Plan Review Comments Response

Project Name: **Kimmelman SFD**

The following is a formal response to the Plan Review Comments completed by Josh Goodman (Code), Joe Bingham (Structural), and checked by DeAnn Wilde. October 23, 2017. (Received October 23, 2017)

Re: Kimmelman SFD – Plan Review Comments

Project			Lot 16R of Summit Eden Phase 1A		
	Analysis Description			Section A-A' - Static - Below Footing		
	Drawn By		EBF	Scale		1:250
	Date		11-15-2017	Company		IGES, Inc.
	SLIDEINTERPRET 7.029		File Name		Section A-A' Static - Footings.slim

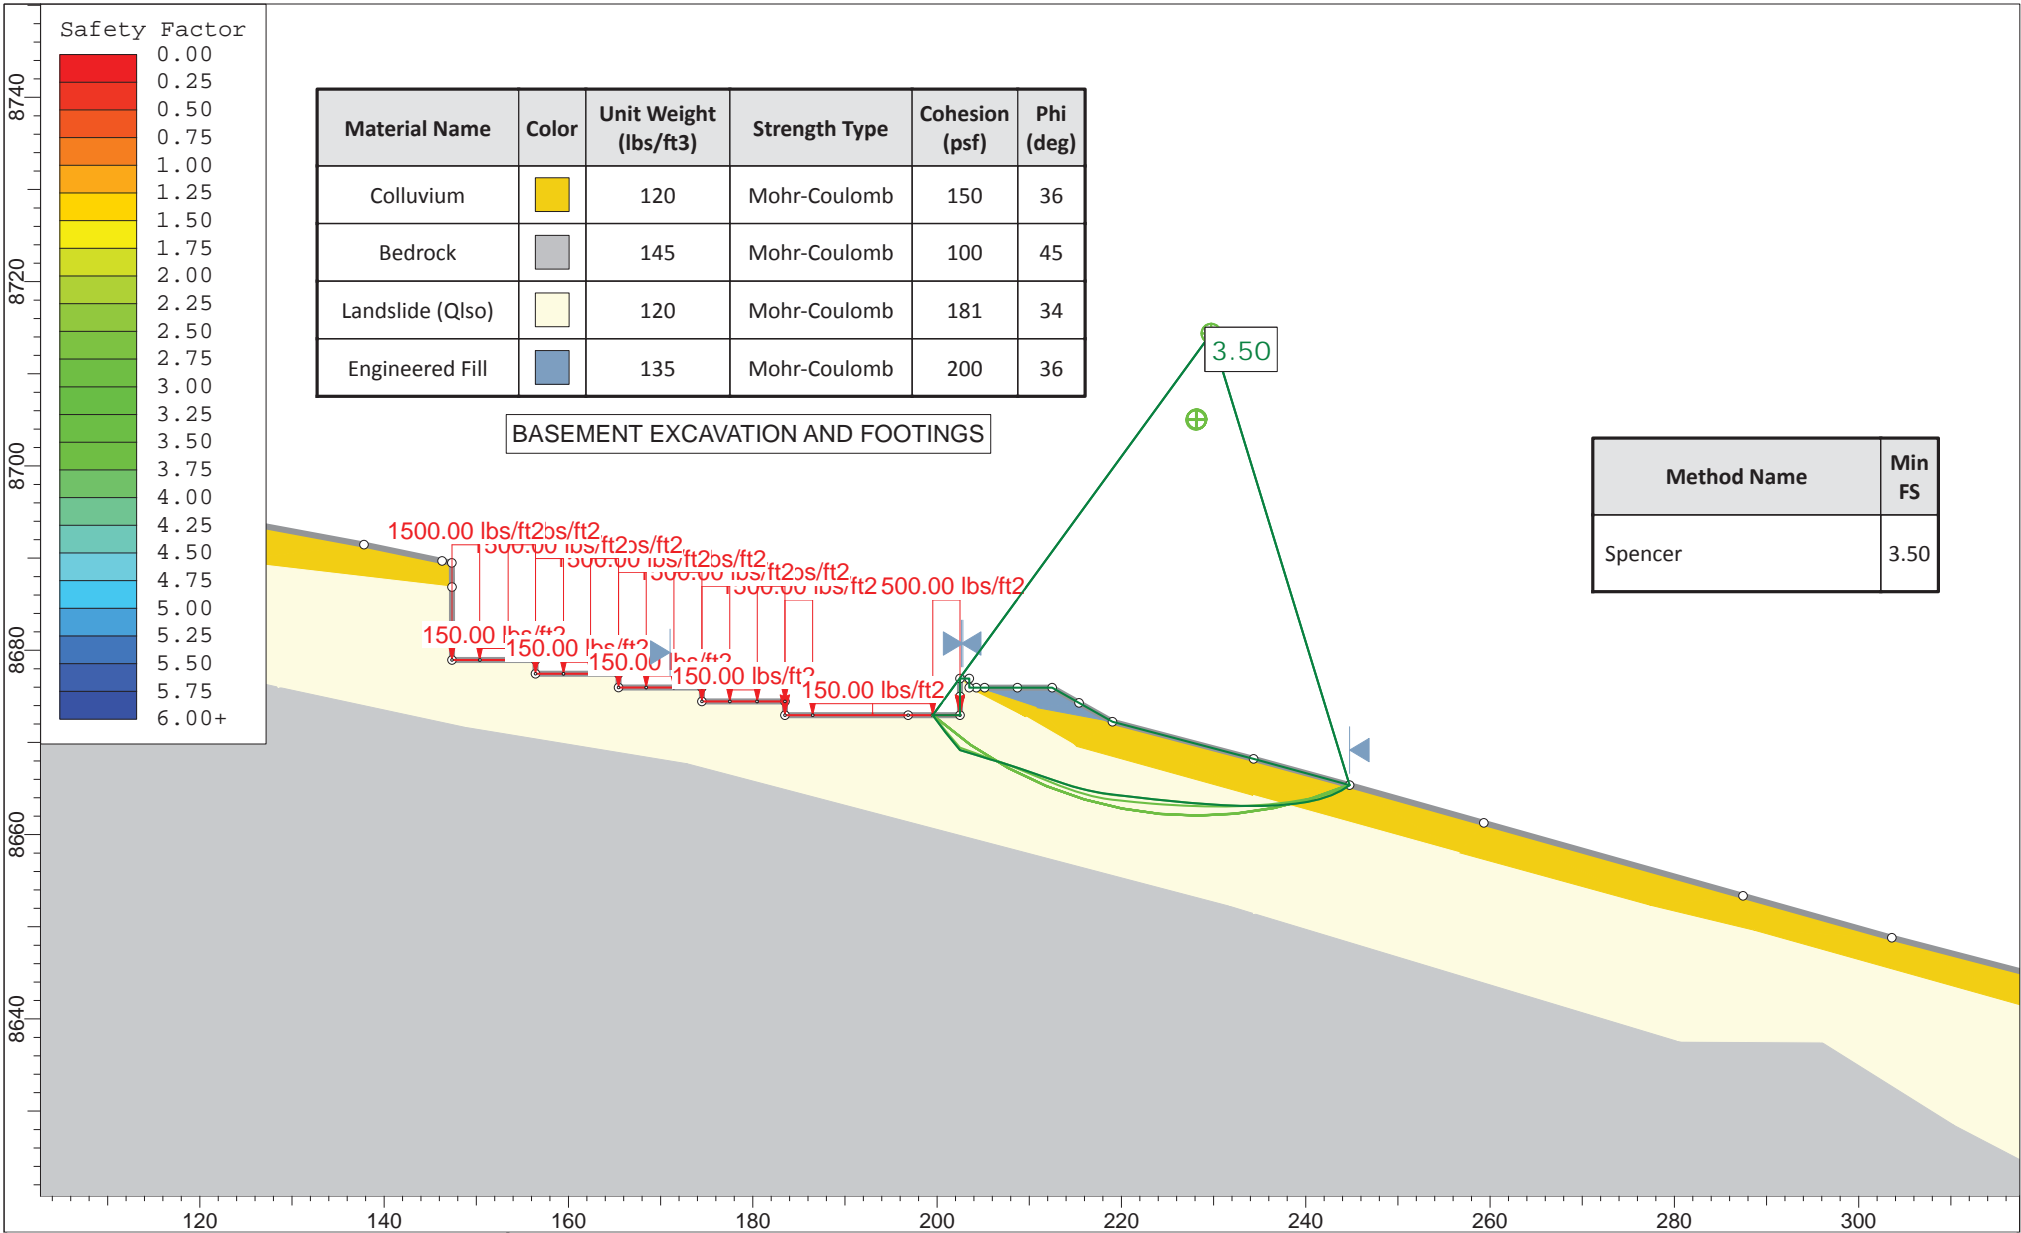
'Sheet A303: Please address the following:

- A. *Based upon the exterior elevations, please detail in writing and on the plans how the requirements of IRC R403.1.7 for footings on or adjacent to slopes have been met.'*

Slope stability analysis was conducted for the worse-case scenario of approximately 16 feet set-back from the descending slope, measured horizontally from face of slope to the bottom of the footing. The analysis was conducted using the same methods and assumptions set forth in our referenced geotechnical report (IGES, 2017). Both static and seismic cases were considered. Analyses were completed for two models – one model allowed a search down-slope, the other

Based on our analysis and our understanding of the proposed construction, the current structural set-back of 16 feet from the face of the slope is considered acceptable from a geotechnical standpoint.

Analysis Description Section A-A' - Seismic - Below Footing

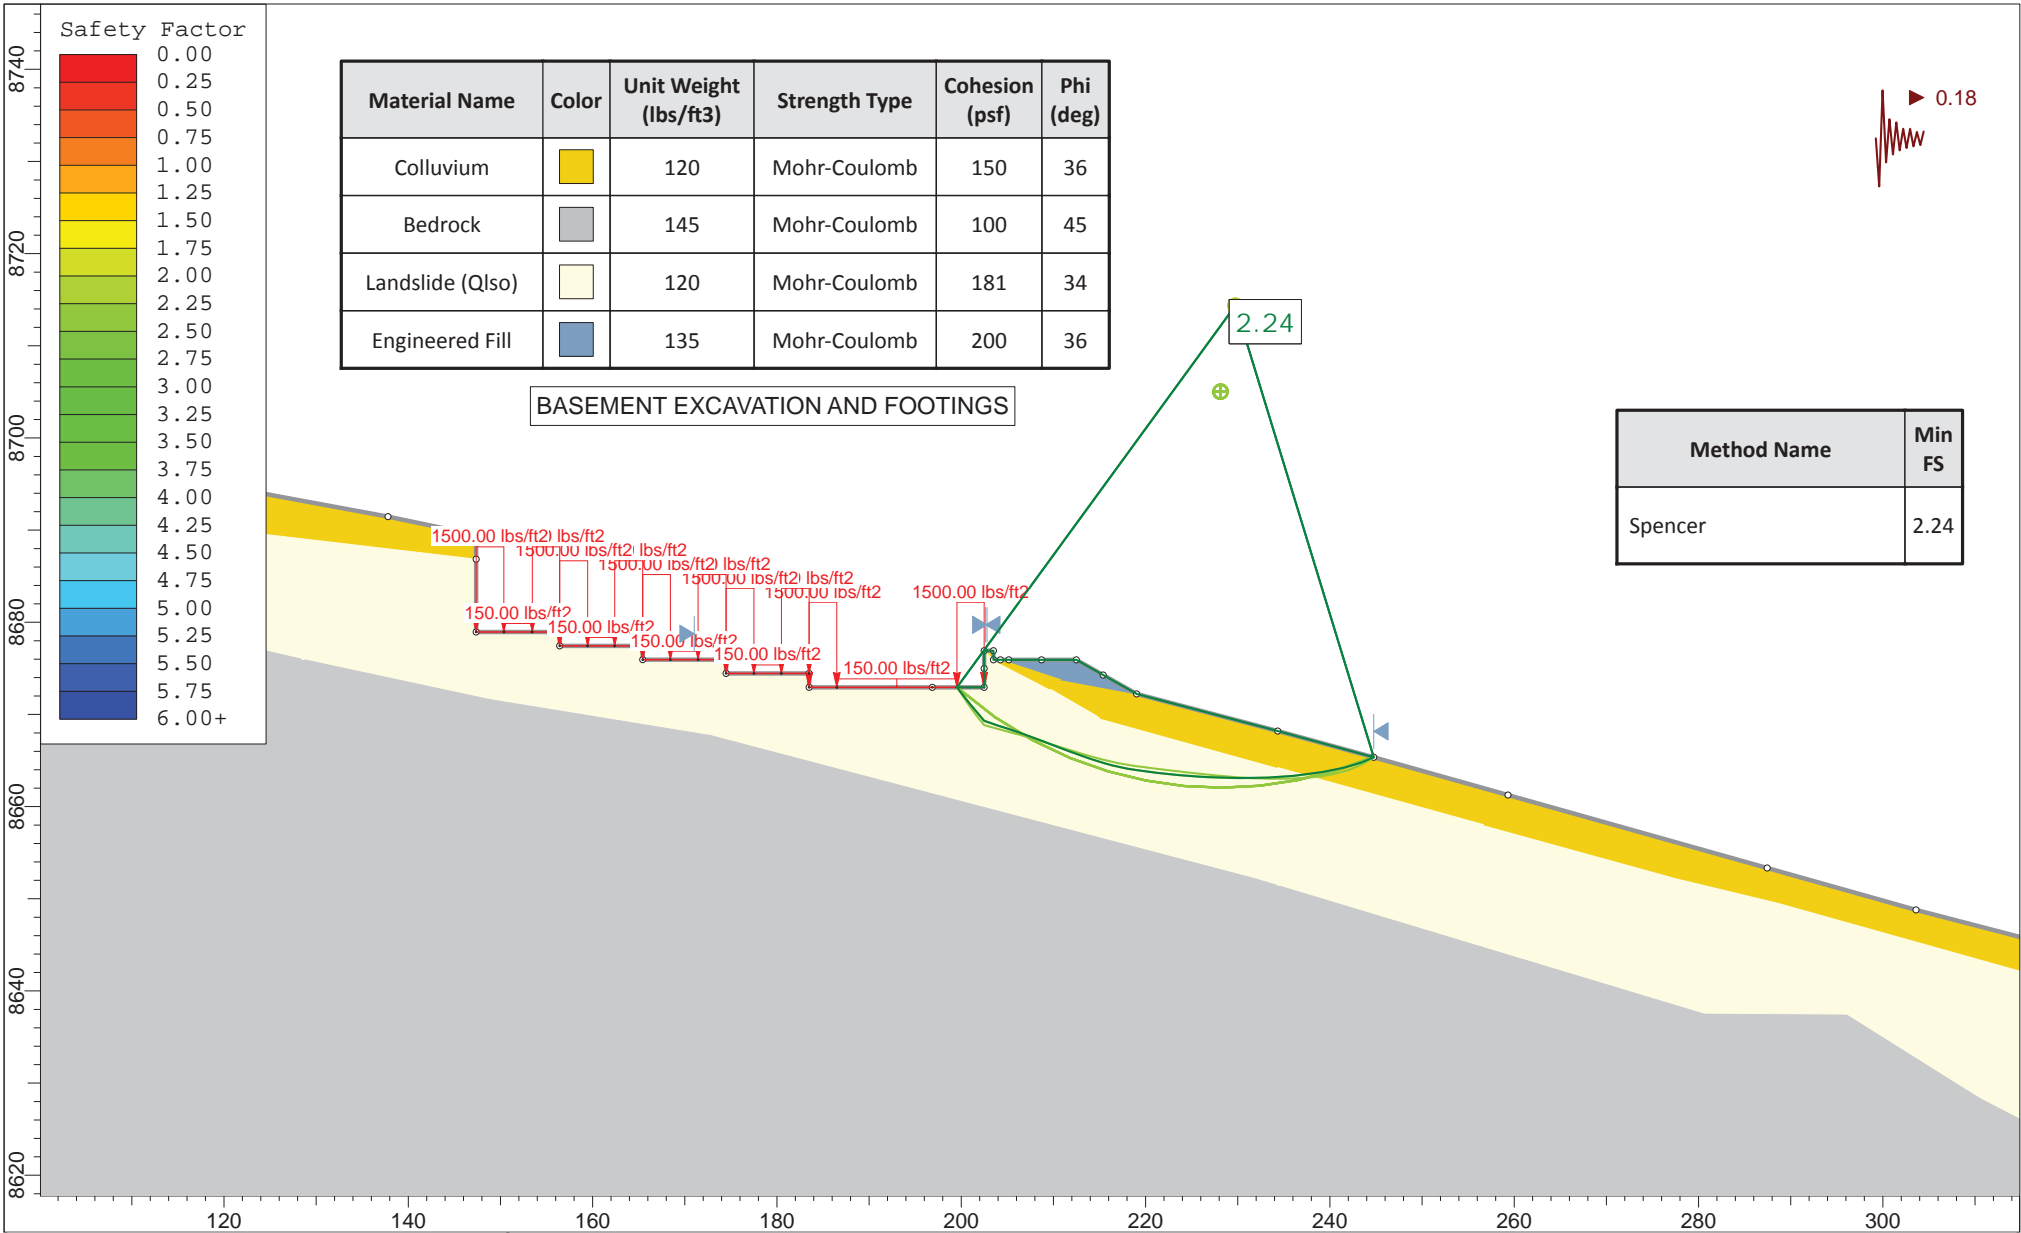
IRC (International Residential Code) R403.1.7 says, in effect, that the base of the footing must be set-back from the face of the slope a minimum of $H/3$, H being the height of the slope, but this set-back need not exceed 40 feet – the exception being, if the geotechnical engineer of record indicates a distance smaller than $H/3$ is acceptable *and* the reduced distance is approved by the *building official*. Since the vertical distance from Lot 16 to the bottom of the drainage is well in excess of 120 feet, the minimum set-back would be 40 feet barring input from a geotechnical engineer or engineering geologist. However, current plans indicate that the minimum structural set-back from the face of the slope will be as little as 16 feet. Accordingly, IGES has conducted supplemental slope stability analysis to assess whether the current grading plan and set-back are appropriate and safe from a geotechnical standpoint.

Based on our analysis, the slope in the vicinity of the home's southern foundations meets the minimum static and seismic factors-of-safety of 1.5 and 1.0, respectively. A summary of our slope stability analysis is attached.
